**BEFORE THE HEARINGS PANEL
FOR THE QUEENSTOWN LAKES PROPOSED DISTRICT PLAN**

IN THE MATTER of Stage 3 and 3b of the
Proposed District Plan

**SECOND REBUTTAL EVIDENCE OF MICHAEL ANDREW SMITH
ON BEHALF OF QUEENSTOWN LAKES DISTRICT COUNCIL**

Transport – Universal Developments at Hāwea

Figure 1

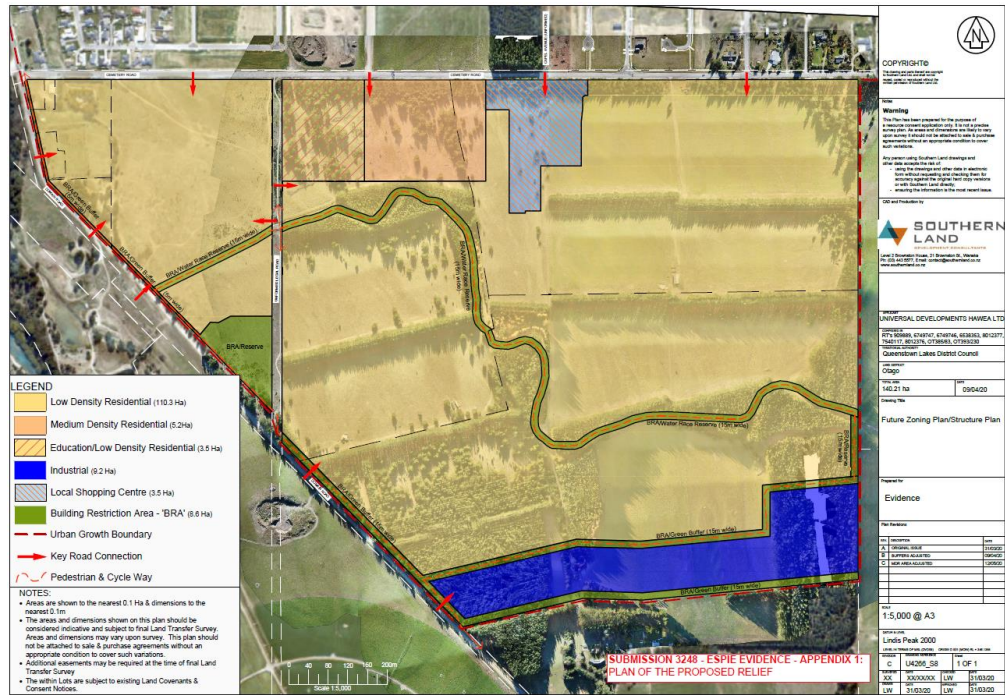
3.3 The submission relates to a large land parcel located to the south of the existing Hāwea Settlement, bounded between Cemetery Road and Domain Road, as shown in the submitter's proposed land zone (**Universal proposal**) diagram copied below (**Figure 1**). I have used this diagram to indicate the nature and extent of the proposed zone framework, along with the indicated key road connections to the existing road network.

3.5 As presented below, I consider that many key constraints have not been identified by Mr Carr, based on the proposal in **Figure 1**. This results in significant impacts which could affect the transportation effects and proposed mitigations put forward by Mr Carr.

- 3.9** While the recreational cycle use of the current path could be transferred to other locations such as the water-race reserve provisions, under the Universal proposal this does not link to the greater east-west road network due to the rural land to the east. The submitter’s land use plan (refer to Figure 1) indicated (small red dashed lines) that the cycle trail could run along the water race reserve, then back through the industrial landscape buffer zone, returning back to Domain Road. The proposed route does not connect back to Cemetery Road, or the greater road network to the east. A landscape strip on the south side of Cemetery Road could be utilised for safe passage of children and a shared path.
